TE Connectivity

Product Change Notification: PCN-23-172471

CAGE ASSEMBLY OF ZQSFP PLUS

Plating process change for center EMI spring

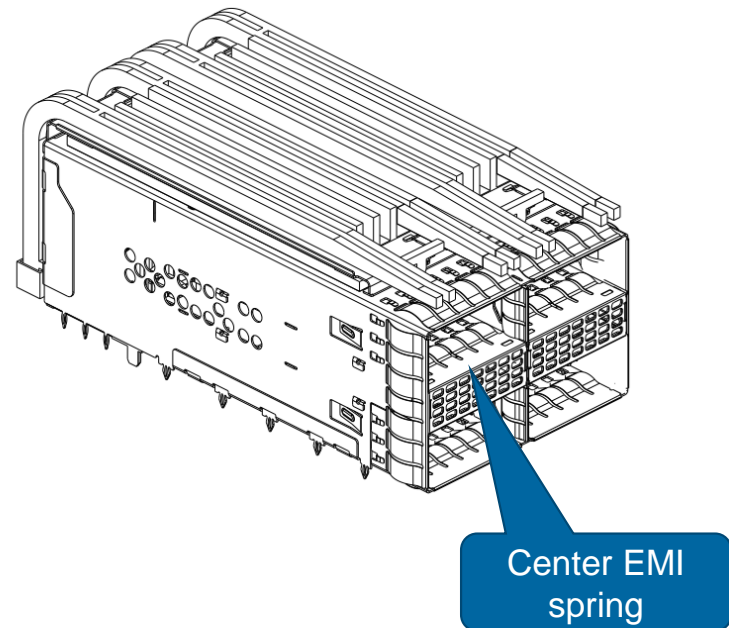
1. Change description:
For center EMI spring of zQSFP+ stack cage assembly,
the nickel plating will be changed from post-plating to
pre-plating
2. Impacted FG:
zQSFP+ Stack Cage Assembly
3. Where changed:
Center EMI spring, see right image
4. Impacted FG part numbers:
See page 2
5. Appearance comparison and salty testing
See page 3 and page 4

Appearance comparison

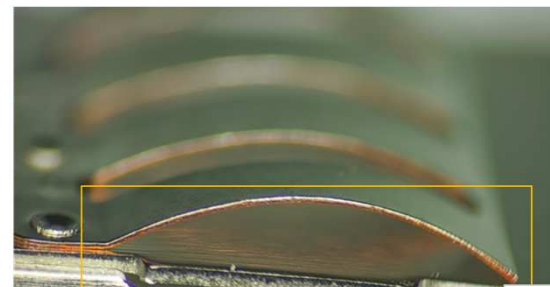
Before: 冲压后电镀(electroplating after stamping)

Not expose substrate at cutting surface

After: 预镀材冲压(stamping after pre-plating)

Expose the substrate at cutting surface

Summary: Except the little difference at EMI cutting surface, there is no obvious difference after assemble to FG for both plating type.
